ADDENDUM NO. 2
May 16, 2024

**PROJECT: EULA INDEPENDENT SCHOOL DISTRICT
ELEMENTARY RENOVATION & ADMIN ADDITION**

1 ELECTRICAL POWER PLAN
3/32" = 1'-0"

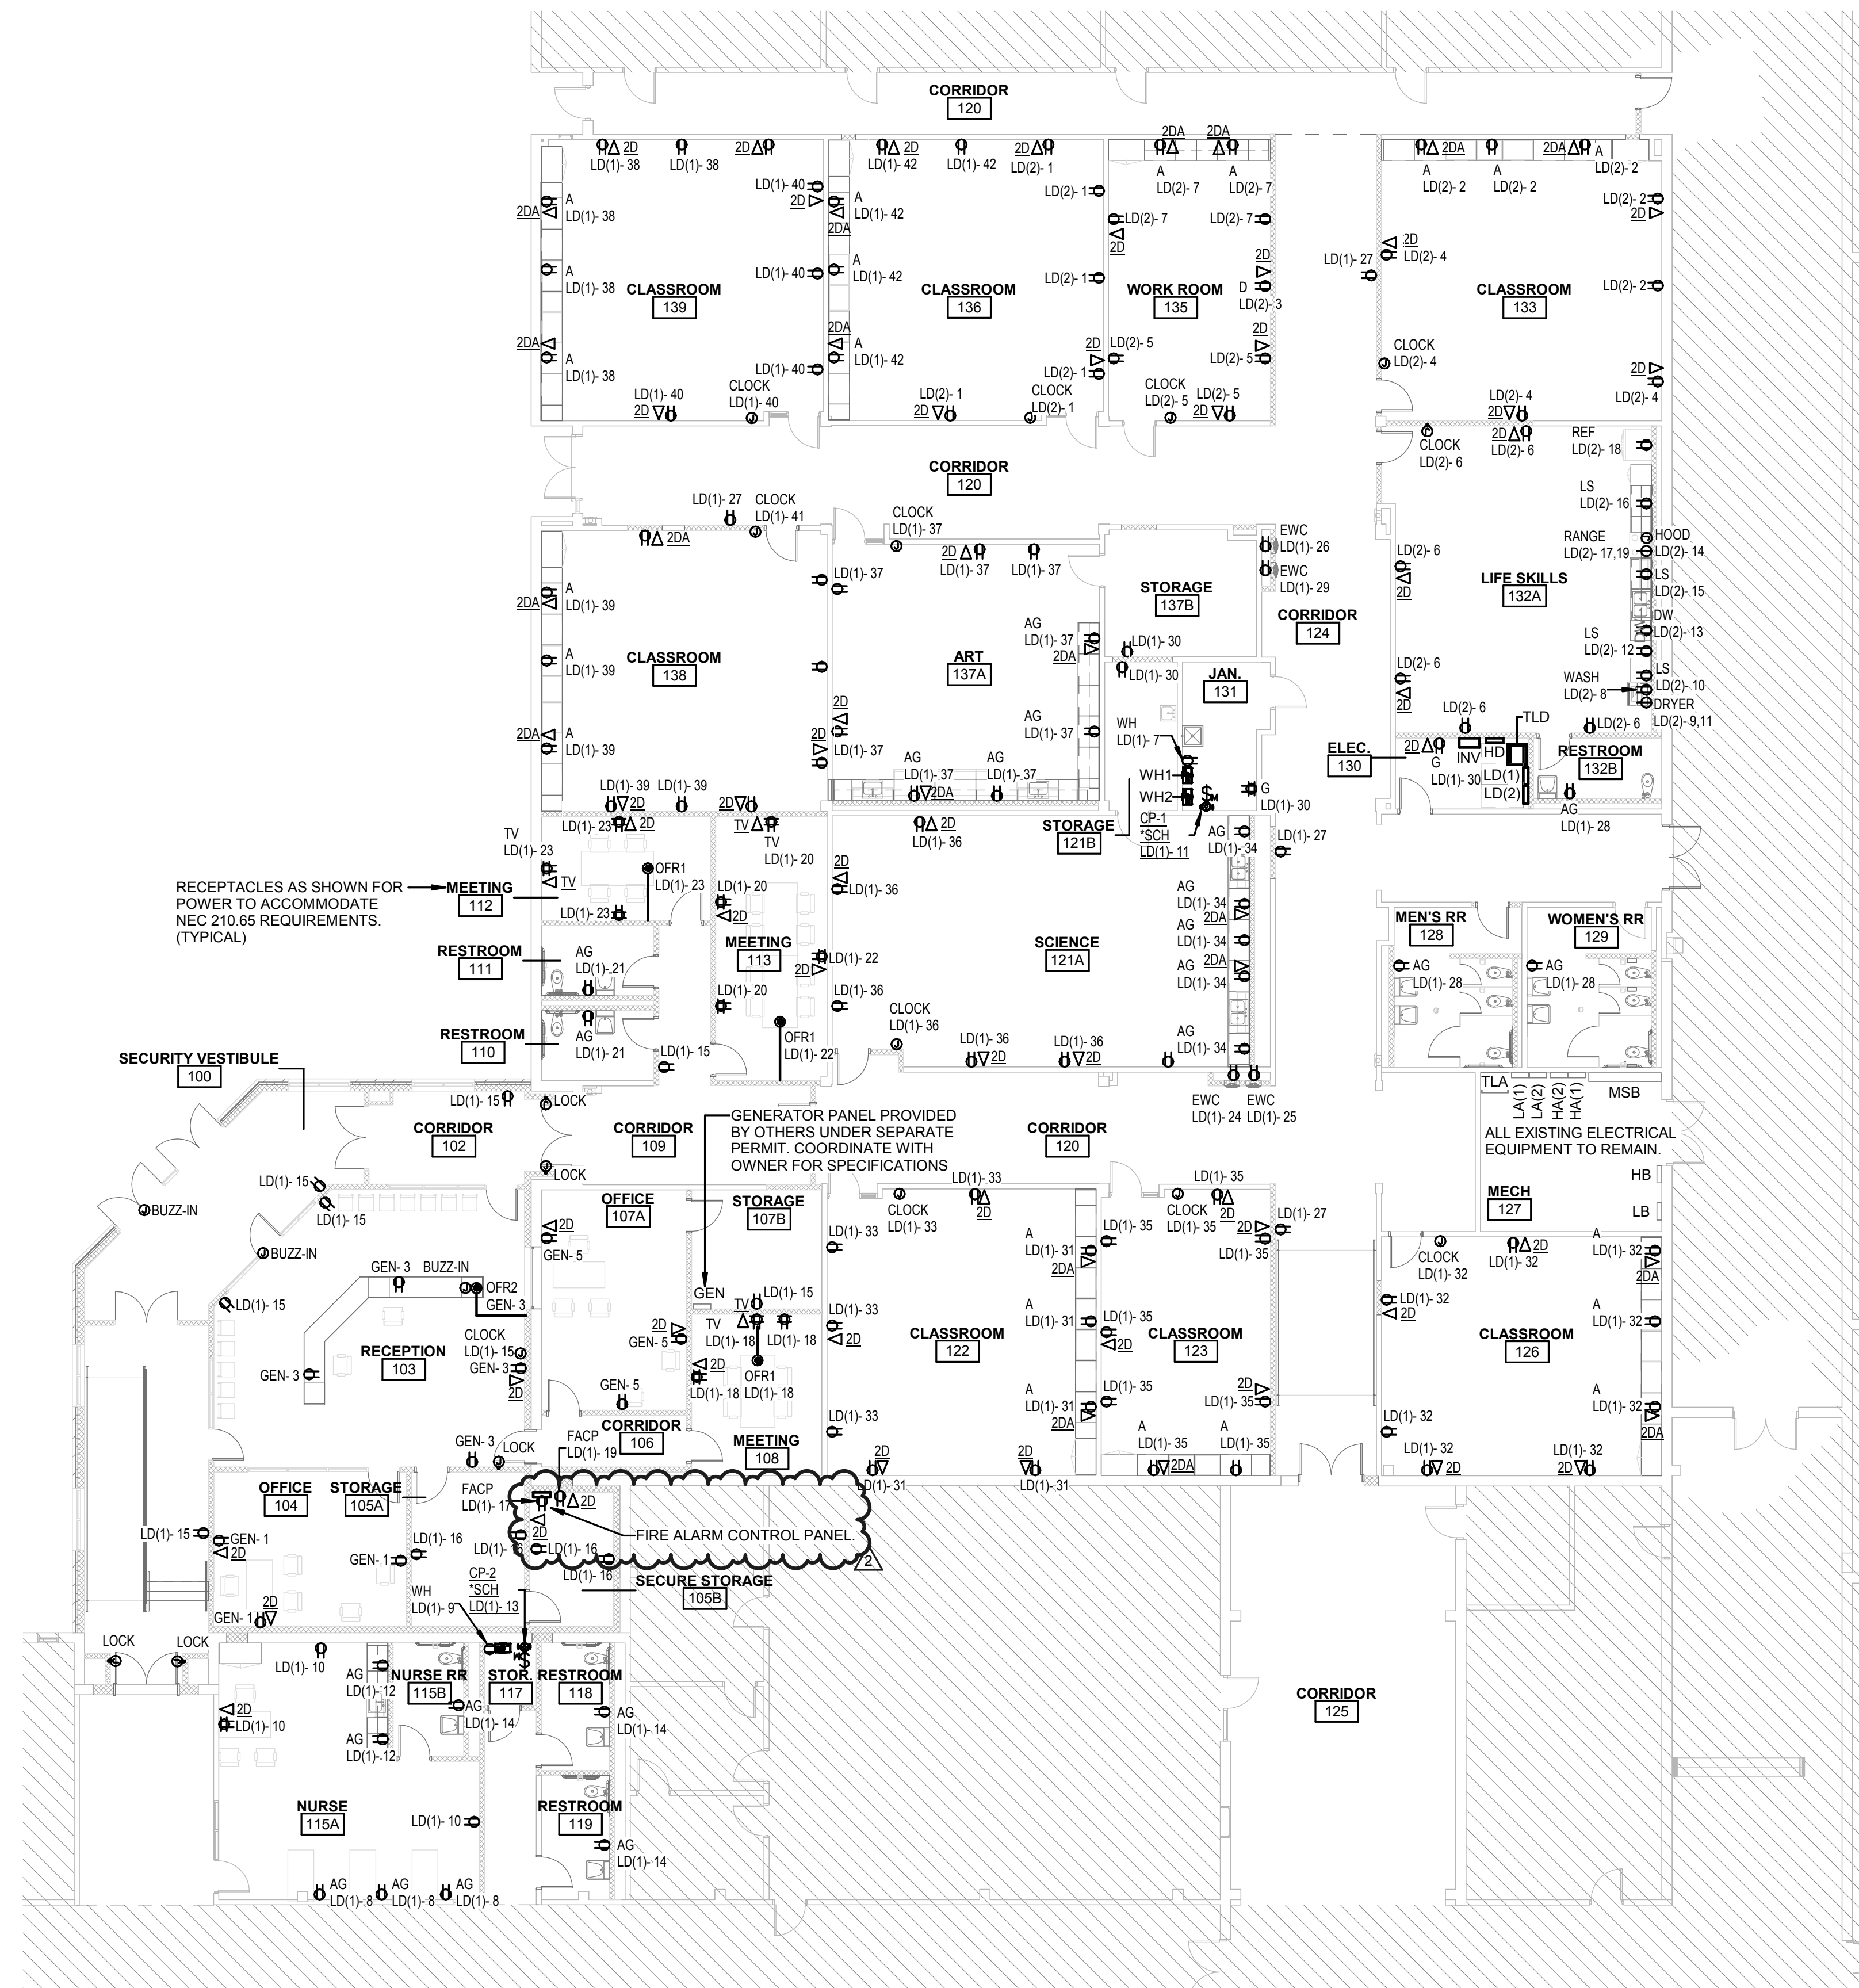
- Item #D2** **Sheet E2.0** – REPLACE sheet with attached sheet E2.0 dated 05-15-2024. UPDATED fire alarm control panel on electrical power plan. UPDATED general power notes and requirements for surface mounted conduit rather than Hubbell service raceways in the renovation portion of the project.

- ### GENERAL POWER NOTES
- WHERE NEW DUPLEX RECEPTACLES INSTALLED IN THE SAME LOCATION ONCE OCCUPIED BY DEMOLISHED RECEPTACLE. RECONNECT NEW DUPLEX RECEPTACLE TO EXISTING CONDUCTORS IN EXISTING RECESSED RACEWAY. THIS SHALL BE A ONE-FOR-ONE REPLACEMENT TO UPDATE ALL FIXTURES TO MATCH IN COLOR AND LOOK. PROVIDE NEW STAINLESS STEEL COVER PLATE. COORDINATE THE COLOR/FINISH OF ALL ELECTRICAL DEVICES AND THEIR COVER PLATES WITH ARCHITECT.

- WHERE NEW POWER/DATE DEVICES ARE SHOWN, BUT NO RECESSED DEVICE IS EXISTING, THE ELECTRICAL CONTRACTOR SHALL PROVIDE SURFACE MOUNTED JUNCTION BOX AND CONDUIT ATTACHED TO EXISTING CMU WALL. ALL SURFACE CONDUIT SHALL BE INSTALLED IN A NEAT AND WORKMANLIKE MANNER. COORDINATE THE COLOR/FINISH OF ALL EXPOSED ELECTRICAL DEVICES AND THEIR COVER PLATES WITH ARCHITECT.

- THE ELECTRICAL CONTRACTOR SHALL MOCKUP ONE CLASSROOM DURING ROUGH-IN FOR ARCHITECT REVIEW AND OWNER APPROVAL PRIOR TO COMPLETING ANY OTHER SPACES. COORDINATE THE ROUTING OF ALL SURFACE MOUNTED CONDUIT WITH FURNITURE INSTALLER. FIELD VERIFY EXISTING CONDITIONS.

1 ELECTRICAL LIGHTING PLAN
3/32" = 1'-0"

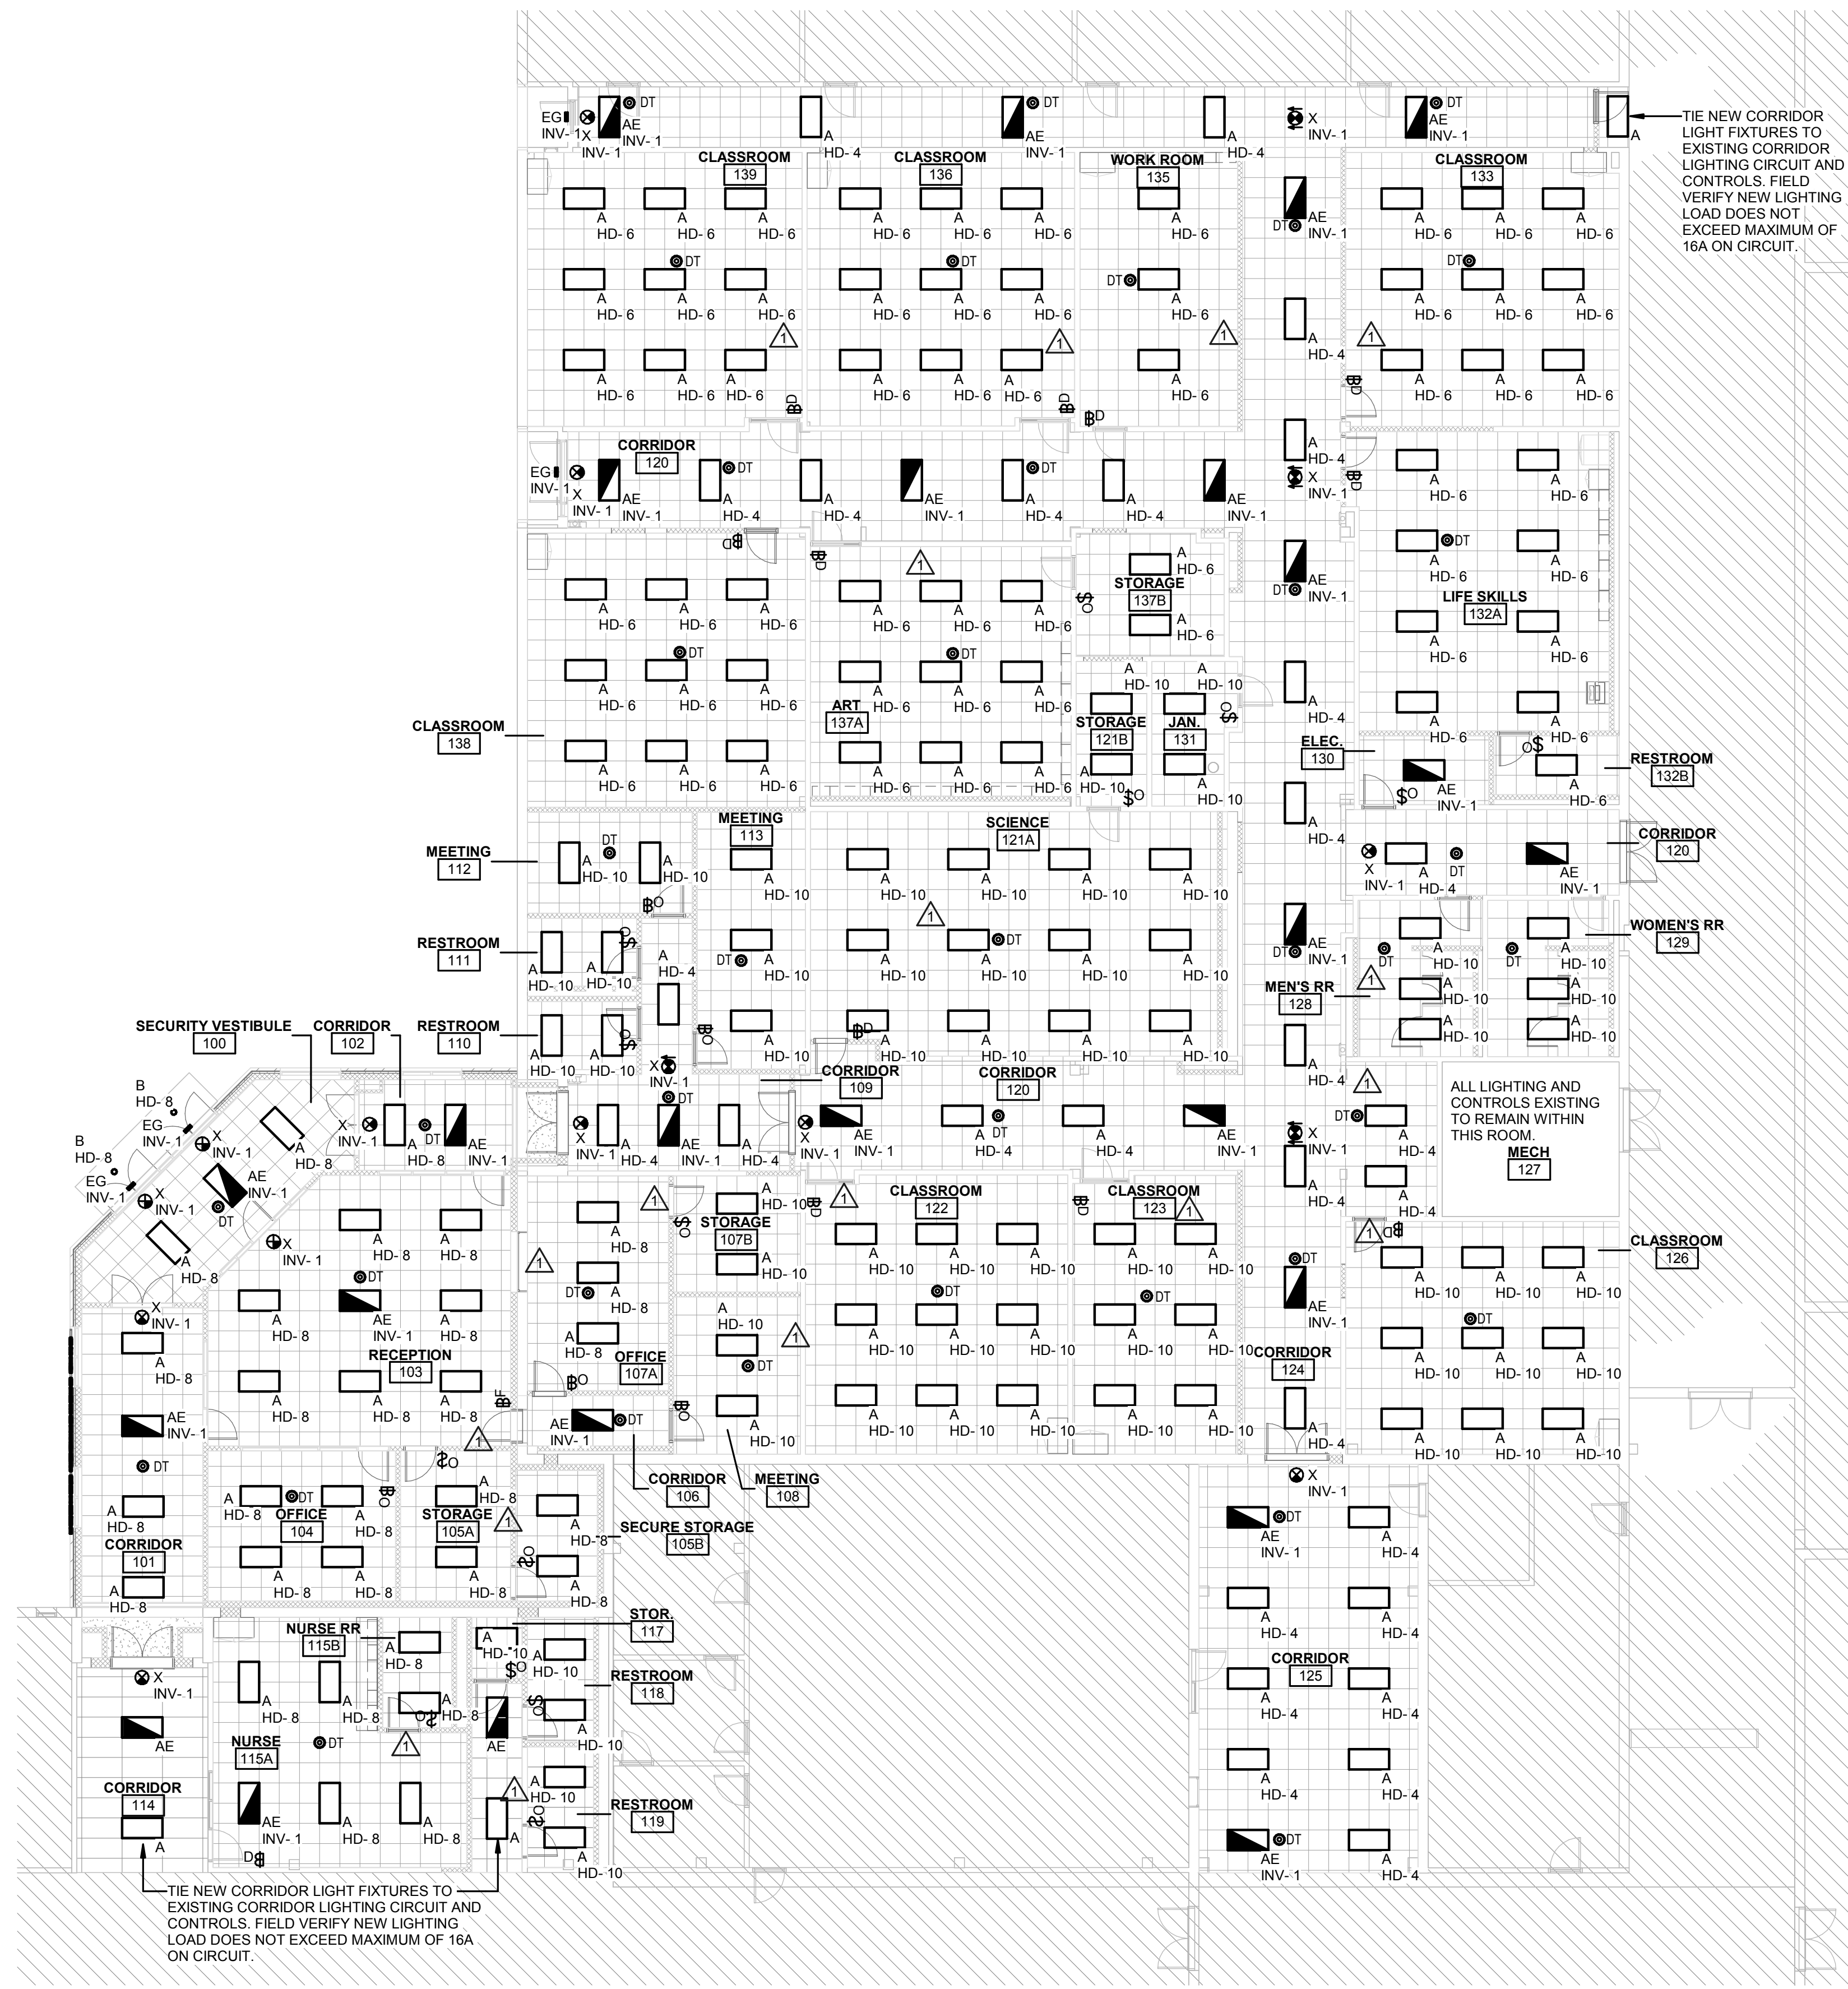
- Item #D3** **Sheet E3.0** – REPLACE sheet with attached sheet E3.0 dated 05-15-2024. UPDATED general lighting notes.

- GENERAL LIGHTING NOTES**
1. INSTALL NEW LIGHTING CONTROL SWITCHES IN LOCATION ONCE OCCUPIED BY EXISTING LIGHTING SWITCHES. FIELD VERIFY EXISTING CONDITIONS. COORDINATE THE COLOR/FINISH OF SWITCHING DEVICES AND THEIR COVER PLATES WITH ARCHITECT.

2. WHERE NEW LIGHT SWITCHES NEED TO BE PROVIDED IN AN LOCATION WHERE THERE IS NOT AN EXISTING DEVICE RECESSED WITHIN THE WALL, THE ELECTRICAL CONTRACTOR SHALL PROVIDE SURFACE MOUNTED JUNCTION BOX AND CONDUIT ATTACHED TO EXISTING CMU WALL. ALL SURFACE CONDUIT SHALL BE INSTALLED IN A NEAT AND WORKMANLIKE MANNER. COORDINATE THE COLOR/FINISH OF ALL EXPOSED ELECTRICAL DEVICES AND THEIR COVER PLATES WITH ARCHITECT.
